Certificate of Compliance Inspection Report - Permit #: SS2022-1548

Owner & Property Information			
Owner Name:	MARCUS JASKEN	Site Address:	28074 CO HWY 26
Mailing Address:	MARCUS JASKEN 28282 YELLOWTAIL TR ROCHERT MN 56578	Township - Sec/Twp/Rng:	RICHWOOD - 12/140/041
Parcel #:	240101001	Legal Description:	12-140-41 PT NW1/4 NW1/4: COMM N QTR COR SEC 12, S 1352.04', W 1635.13' TO POB; N 762.73', W 685.18', S 762.73', E 685.18' TO POB.
Secondary Parcel #:		Designer:	Darryl Bergstrom Backhoe Services, L478 (Darryl Bergstrom)
		Installer:	Darryl Bergstrom Backhoe Services, L478 (Darryl Bergstrom)

Field Review Form

Septic Permit

SKETCH OF PROPERTY

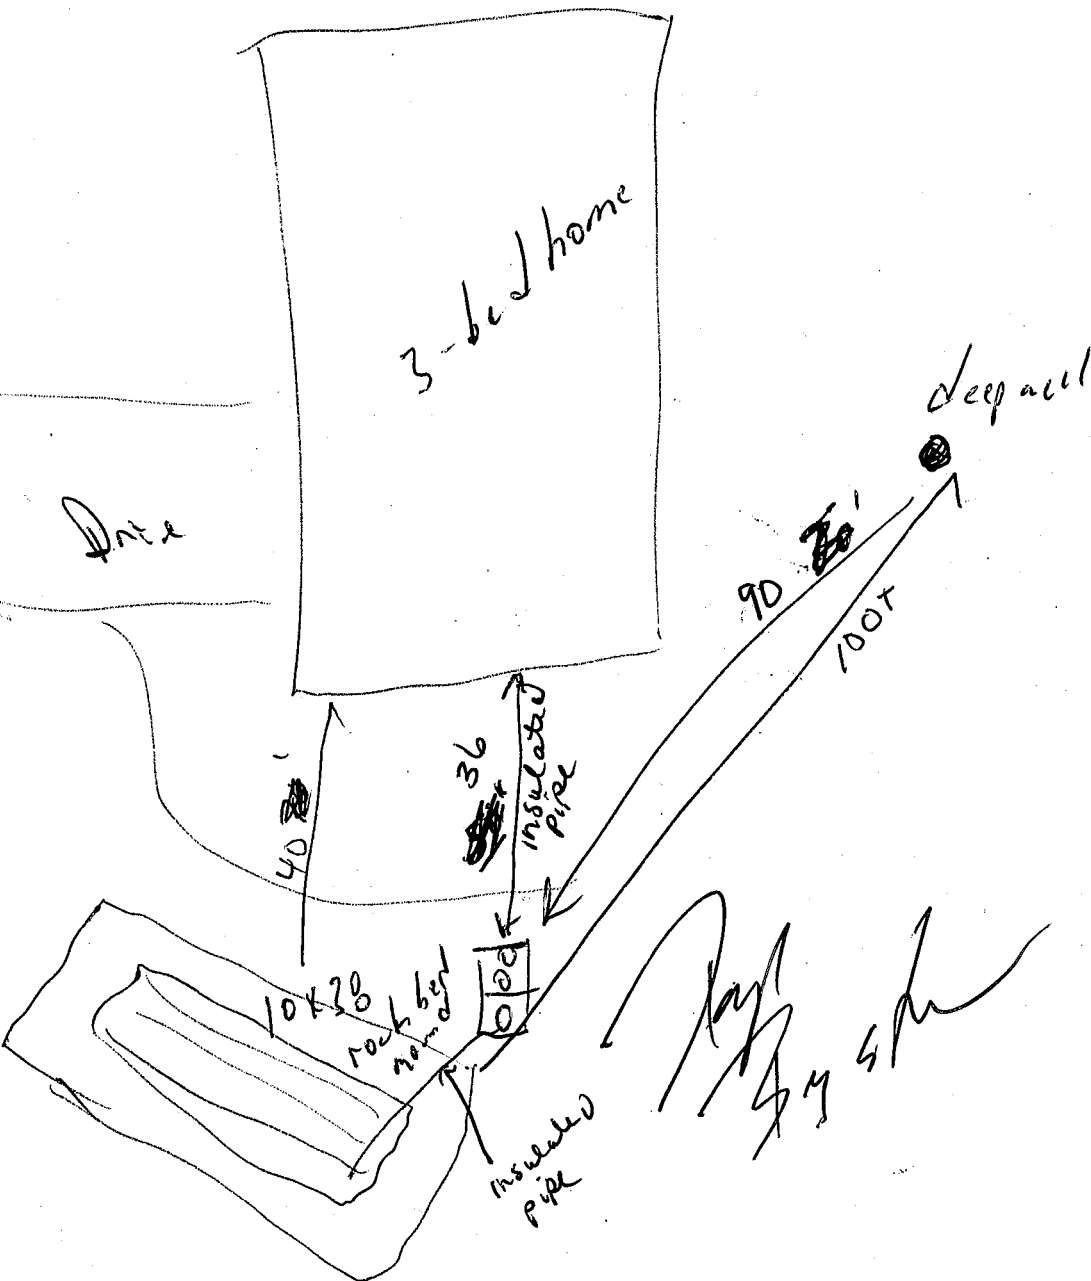
1500/2 Brown
insulate pipe
to tank &
manhole

PS Patrol
Zoller BN 151
10'x38' Rock bed
50'x38' SAN

1' soil ok
Pit sunny

soils + setbacks ok
Certify
Denise Gubrud
